[Issue No.] HIME-T-P-0190A

[Title] Changes in the nameplate according to the compliance with European Consistent Standard  
EN61010-2-201: 2013

[Relevant Models] MELSEC-F series

Ex.) For FX3U-64MR/UA1

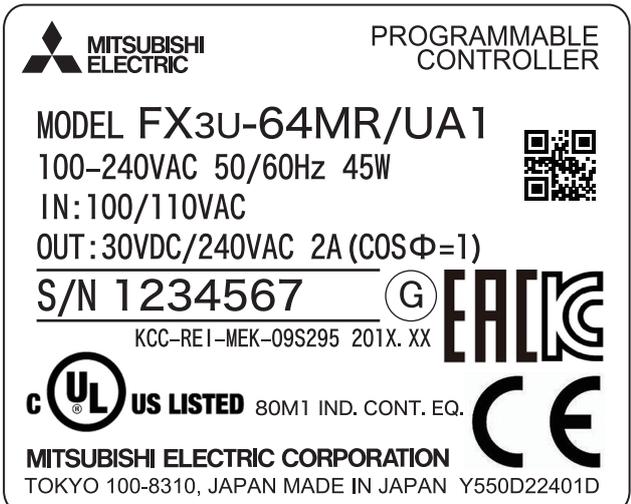
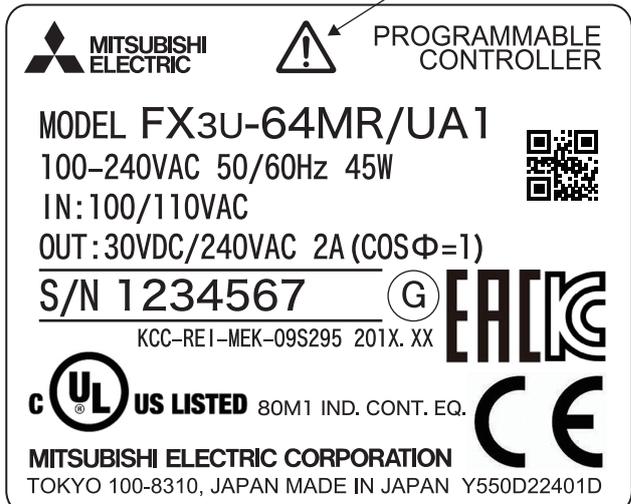
Before change	After change
 <p>The nameplate before change shows the Mitsubishi Electric logo, 'PROGRAMMABLE CONTROLLER', model 'FX3U-64MR/UA1', and various technical specifications. It includes a QR code, a 'G' mark, and safety certifications like UL and CE.</p>	 <p>The nameplate after change is identical to the one before, but with a new warning triangle symbol (⚠) added to the top right. An arrow points to this symbol with the text 'Changed point'.</p>

#### Changed point

- ⚠ Mark added.

The ⚠ mark on this nameplate indicates the instruction to refer to the manual during installation.
